JOINT REGIONAL PLANNING PANEL (NORTHERN REGION)

SUPPLEMENTARY REPORT & CONDITIONS 10 DECEMBER 2013

CLARIFICATION OF APPROVED USES AND APPLICABLE s64 WATER & SEWER CHARGES

JRPP No	2013NTH021
DA Number	DA13/0554
Local Government Area	Tweed Shire Council
Proposed Development	Alterations & additions to the Tweed City Shopping Centre to accommodate a new Entertainment Leisure Precinct (ELP) & a new mini major extension. The development will result in a total gross floor area increase of 4,178m ² , removal of the existing elevated car park, internal demolition & reconfigurations, new outdoor areas (including children's playground), revised loading docks adjoining the ELP, first-use approvals & revised car parking areas.
Street Address	Lot 4 DP 781506; No. 34 Minjungbal Drive; Lot 5 DP 781506; No. 36 Minjungbal Drive; Lot 6 DP 1119624; No. 38 Minjungbal Drive; Lot 1 DP 781517; No. 58 Minjungbal Drive; Lot 2 DP 781518; No. 60 Minjungbal Drive; Lot 1 DP 524806; No. 62 Minjungbal Drive; TWEED HEADS SOUTH, NSW, 2486
Applicant	Dexus Funds Management Ltd
Owner	SAS Trustee Corporation

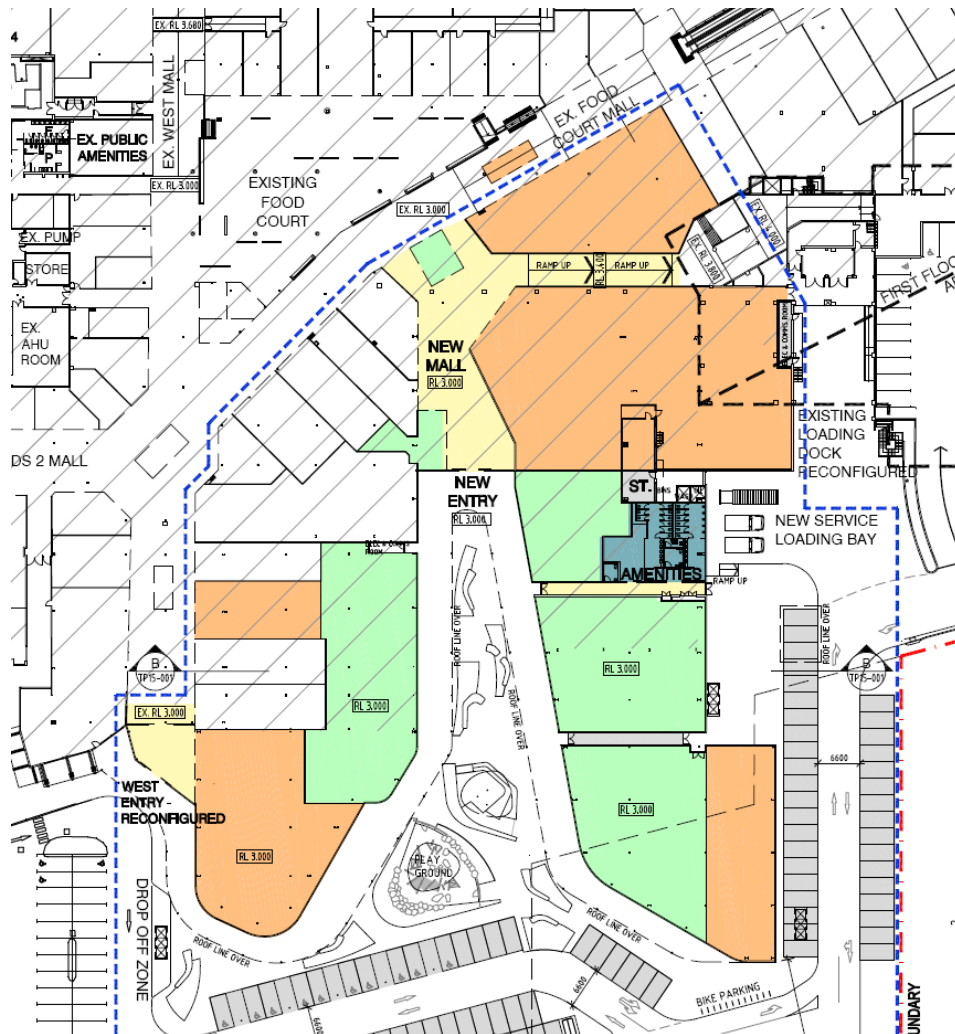
The plans proposed to be stamped (specifically within the entertainment and leisure precinct) show the nominated use of each tenancy as either retail shop (orange) or a food and beverage outlet (green) as follows:

Council's Original JRPP Report considered these proposed uses (retail and food and drink premises) for the purposes of permissibility, car parking and S94 Plan No. 4 Tweed Road Contribution however Council failed to clearly condition what approvals were necessary for the future food and beverage fit outs and failed to charge s64 Developer Contributions (water and sewer) for the proposed food and beverage outlets as these were only charged as shops.

If this was not rectified as part of the current application additional S64 Developer Contributions would be chargeable at the fit out stage which could slow down the process at a later date. For consistency Council is requesting that the subject application rectify this matter and ensure that permissibility, parking, and all developer contributions are assessed for the same land uses (shops and food and beverage premises) as sought by the applicant as part of this application.

New Condition 2

This consent has approved the use of the tenancies for either retail purposes or as a food and drink premises as shown on the Proposed Site & Ground Floor Plan TP12-001 Revision 3 prepared by NH Architecture and dated 26/09/2013. This consent has levied car parking and developer contributions on this basis.

The kitchen fit out of the nominated food and drink premises is yet to be approved and must be the subject of a separate Development Application or Complying Development Application (as statutorily required) prior to issue of an Occupation Certificate for these tenancies.
